Comments and/or Proposals
regarding to
The Revision of GTR22

prepared by JAPAN

64th EVE IWG
19th & 20th September 2023

Regarding “EVE-61-13er1-GTR22 working draft v3 with meeting revisions.doc” , Japan follows EVE IWG decision but has comment and proposal

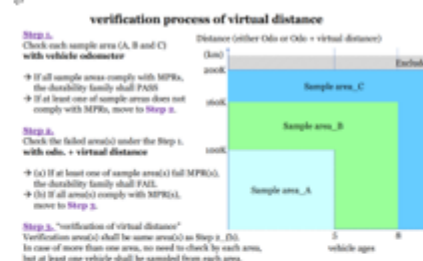
JE **RC Elena Paffoni**
EVE-63-10 Japan proposal on virtual distance verification⁶⁴
See below in track changes⁶⁴

Shall we add in the text also the proposal here in the picture on the selection criteria for the vehicles for the step3?⁶⁴

JE **RC Elena Paffoni**
As defined above⁶⁴
Odometer with virtual distance is defined as⁶⁴
total distance⁶⁴

JE **RC Elena Paffoni**
A sentence might be added to explain the test procedure, i.e., during the verification test, switching on the V2X/ non-traction purposes systems reading the counter?⁶⁴
How long for?⁶⁴

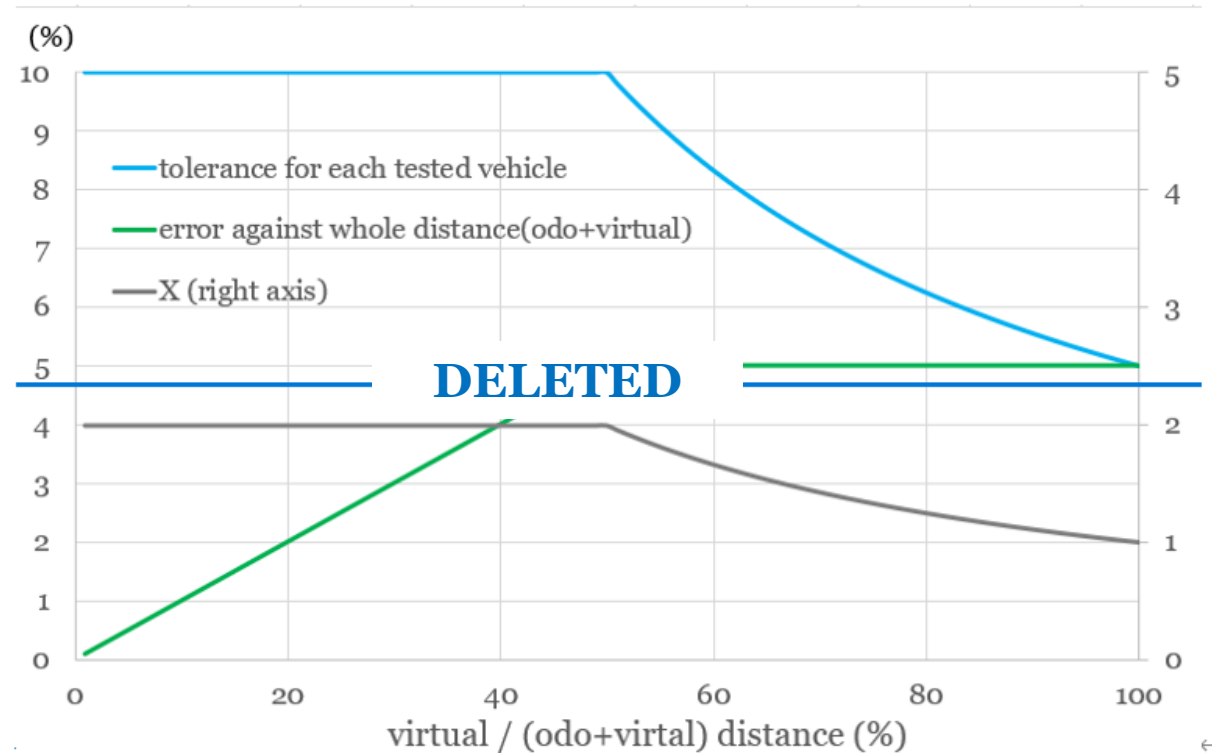
J **JM**
As a way of thinking, an error of 5% of Total Distance is acceptable. However, since the accuracy is not very good, an upper limit is set. See graph on next page⁶⁴

As a way of thinking, an error of 5% of Total Distance is acceptable. However, since the accuracy is not very good, an upper limit is set. See graph on next page

Flow chart for Part B : Verification of Battery Durability and Virtual Distance

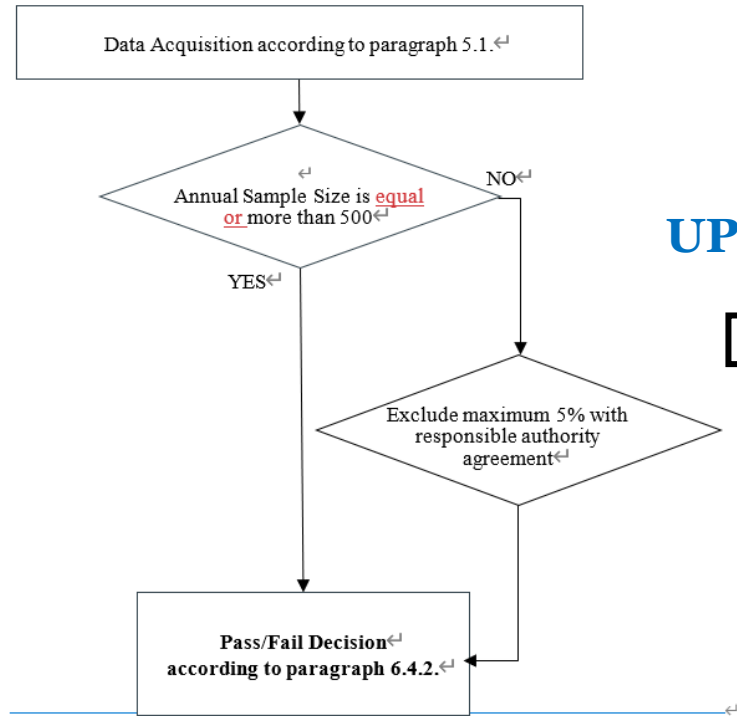
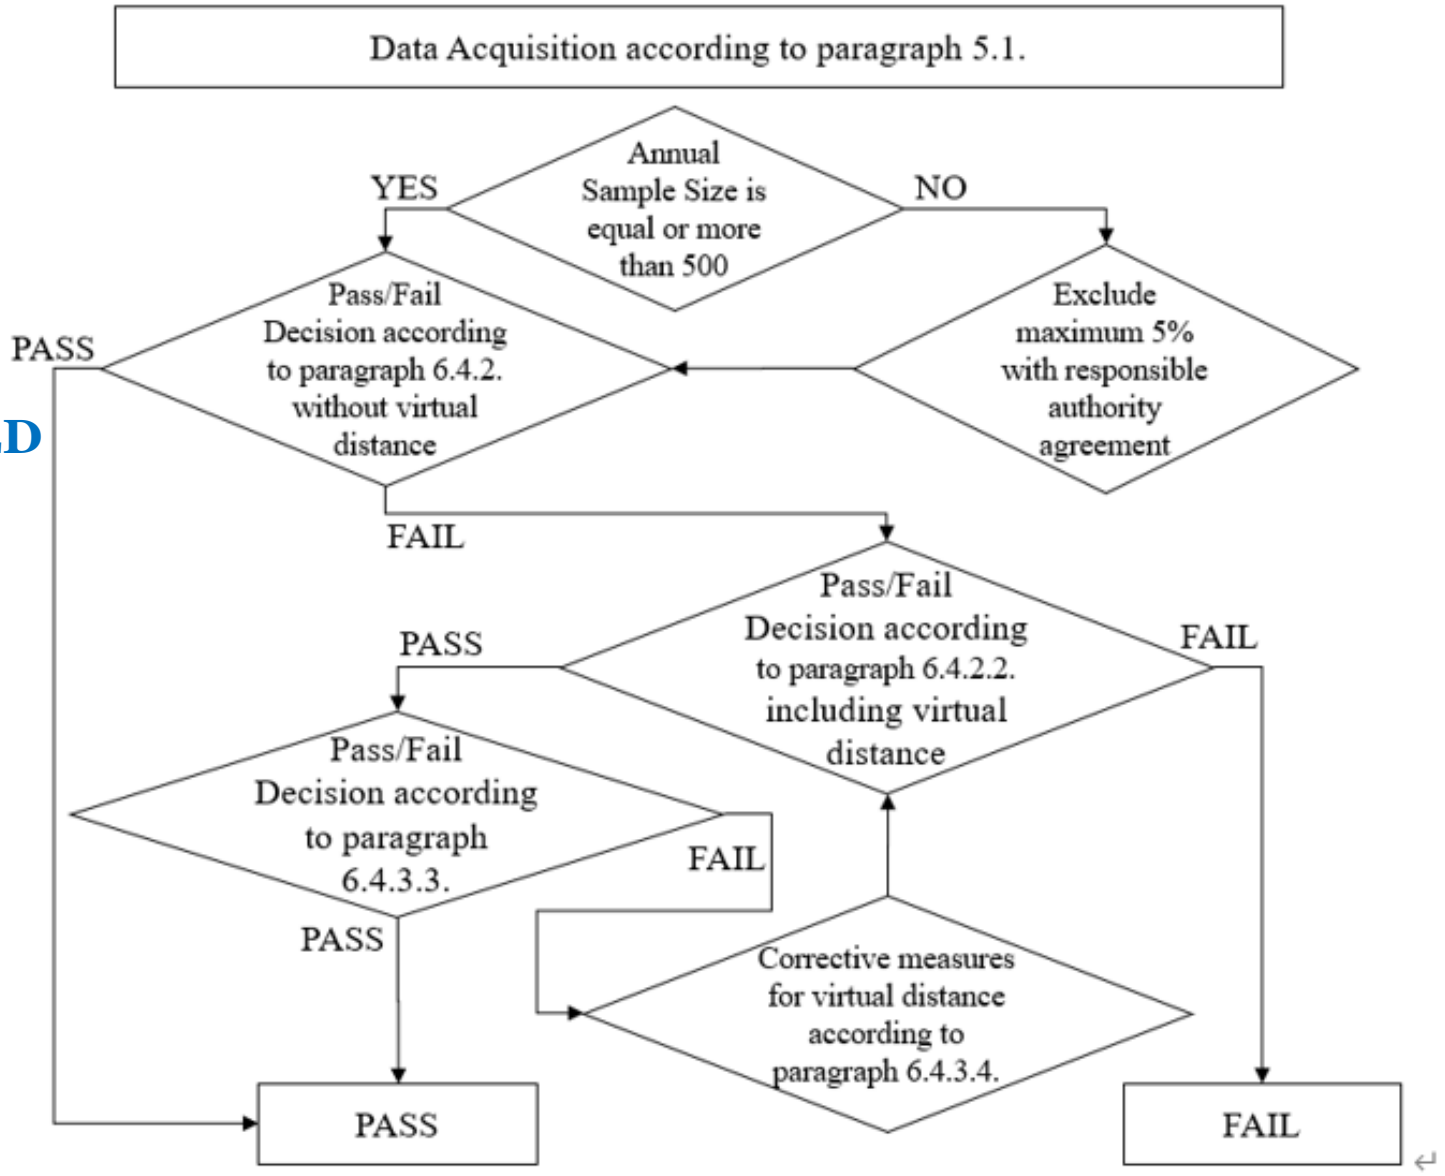
Part B : Verification of Battery Durability and Virtual Distance

UPDATED
